A.T.S. Apparels Limited (Extension)

23 December 2025

1. Two storied Finished Goods Storage Shed-2.

Observation-01: Credibility of material test report. (Finished Goods Storage Shed-2)

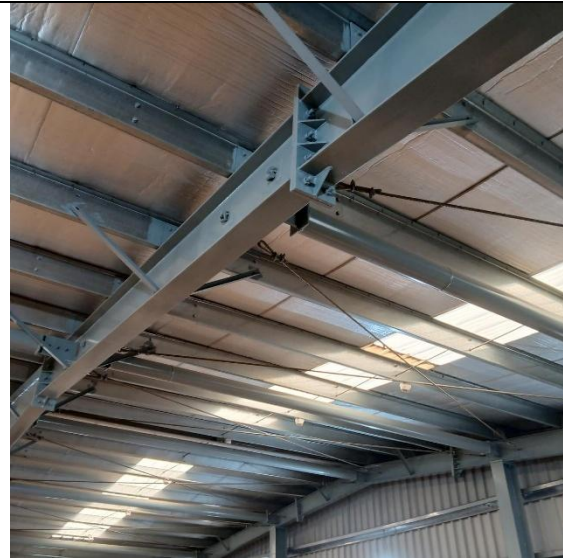
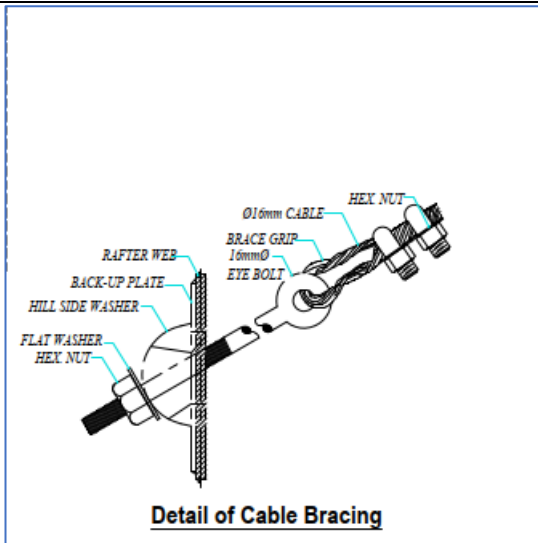
Description: A set of design reports was prepared considering a tensile strength of 348 MPa (50 ksi) for the MS plates; however, no credible test report was available to substantiate this assumption. Although the factory provided a product quality certificate, the name of the purchasing factory was not mentioned in the certificate. Therefore, the certificate is not acceptable to confirm the tensile strength of the MS plates used in the shed.

The factory is required to revise the design report by confirming the tensile strength of the MS plates through a credible and traceable test report.
